**Point Beach Nuclear Plant**

License Amendment Request 259

Application for Technical Specification Improvement to Adopt  
TSTF-490, Revision 0, Deletion of E Bar Definition and  
Revision to Reactor Coolant System (RCS) Specific Activity  
Technical Specification

**LICENSE AMENDMENT REQUEST 259**

Figure 3.4.16-1 (page 1 of 1)  
~~Reactor Coolant DOSE EQUIVALENT I-131 Specific Activity Limit Versus~~  
~~Percent of RATED THERMAL POWER~~

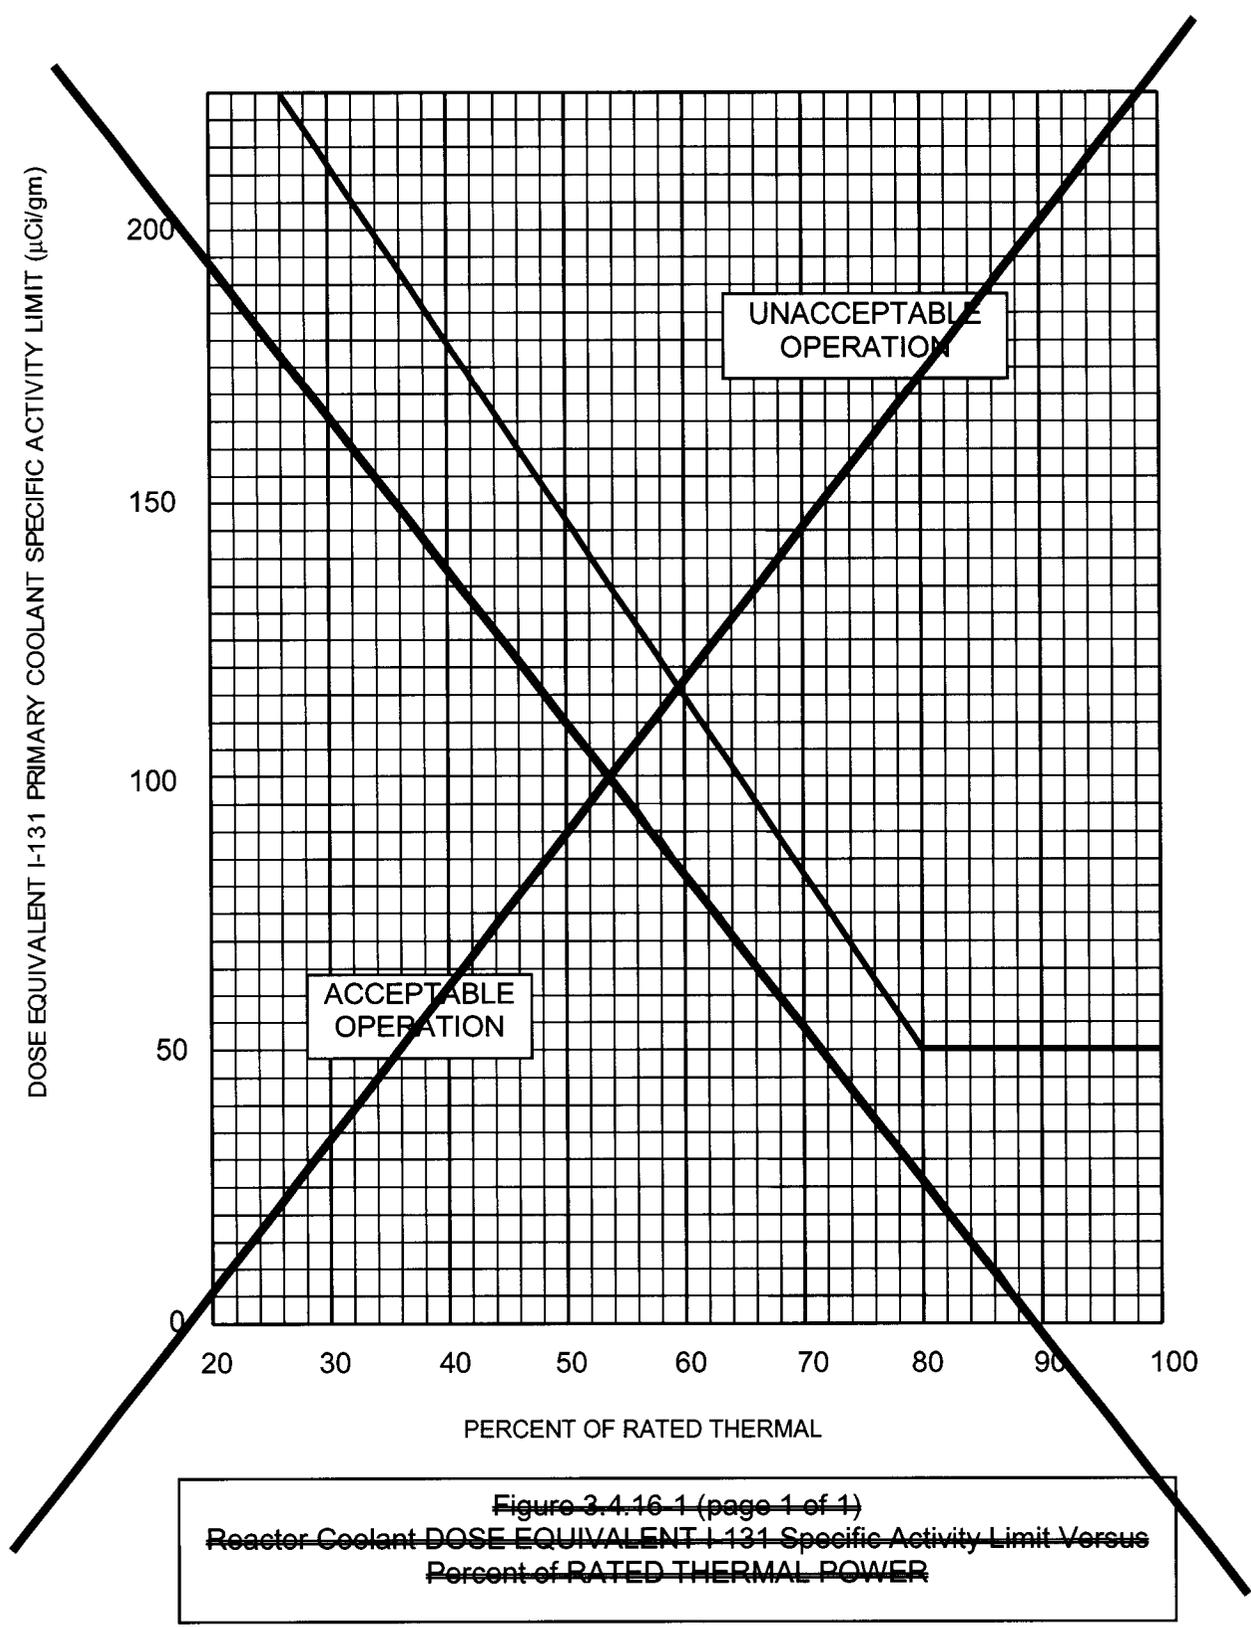
1. CONDITION A is modified to delete the reference to Figure 3.4.16–1, and define an upper limit that is applicable at all power levels.
2. CONDITION B is modified to provide a CONDITION and REQUIRED ACTION for DOSE EQUIVALENT Xe–133 instead of gross specific activity. The Completion Time is changed from 6 hours to 48 hours. A Note allowing the APPLICABILITY of LCO 3.0.4.c is added, consistent with the Note to REQUIRED ACTION A.1.
3. CONDITION C is modified based on the changes to CONDITIONS A and B and to reflect the change in the LCO APPLICABILITY.

CONDITION	REQUIRED ACTION	COMPLETION TIME
A. DOSE EQUIVALENT I-131 <u>not within limit.</u>	<p>-----Note----- LCO 3.0.4.c is applicable. -----</p> <p>A.1 Verify DOSE EQUIVALENT I-131 <del>within the acceptable region of Figure 3.4.16-1.</del> <u><math>\leq 50 \mu Ci/gm.</math></u></p> <p><u>AND</u></p> <p>A.2 Restore DOSE EQUIVALENT I-131 to within limit.</p>	<p>Once per 4 hours</p> <p>48 hours</p>
B. <del>Gross specific activity of the reactor coolant not within limit.</del> <u>DOSE EQUIVALENT Xe-133 not within limit.</u>	<p><del>B.1 Be in MODE 3 with <math>T_{avg} &lt; 500^{\circ}F</math>.</del></p> <p>-----Note----- <u>LCO 3.0.4.c is applicable.</u> -----</p> <p><u>B.1 Restore DOSE EQUIVALENT Xe-133 to within limit.</u></p>	<p><del>6 hours</del></p> <p><u>48 hours</u></p>

CONDITION	REQUIRED ACTION	COMPLETION TIME
<p>C. Required Action and associated Completion Time of Condition A <u>or B</u> not met.</p> <p><u>OR</u></p> <p>DOSE EQUIVALENT I-131 <del>in the unacceptable region of Figure 3.4.16-1.</del> <u>&gt;50 <math>\mu</math>Ci/gm.</u></p>	<p>C.1 Be in MODE 3. <del>with <math>T_{avg} &lt; 500^{\circ}</math>F.</del></p> <p><u>AND</u></p>	6 hours
	<p><u>C.2 Be in MODE 5.</u></p>	<u>36 hours</u>

~~The safety analysis shows the radiological consequences of an SGTR accident are within a small fraction of the Reference 1 dose guideline limits. Operation with iodine specific activity levels greater than the LCO limit is permissible, if the activity levels do not exceed the limits shown in Figure 3.4.16-1, in the applicable specification, for more than 48 hours. The safety analysis has concurrent and pre-accident iodine spiking levels up to 50  $\mu\text{Ci/gm}$  DOSE EQUIVALENT I-131.~~

~~With the DOSE EQUIVALENT I-131 greater than the LCO limit, samples at intervals of 4 hours must be taken to demonstrate that the limits of Figure 3.4.16-1 are not exceeded. The Completion Time of 4 hours is required to obtain and analyze a sample. Sampling is done to continue to provide a trend.~~

Operation with iodine specific activity levels greater than the LCO limit is permissible, if the activity levels do not exceed 50  $\mu\text{Ci/gm}$  for more than 48 hours.

With the DOSE EQUIVALENT I-131 greater than the LCO limit, samples at intervals of 4 hours must be taken to demonstrate that the specific activity is  $\leq 50$   $\mu\text{Ci/gm}$ . The Completion Time of 4 hours is required to obtain and analyze a sample. Sampling is continued every 4 hours to provide a trend.
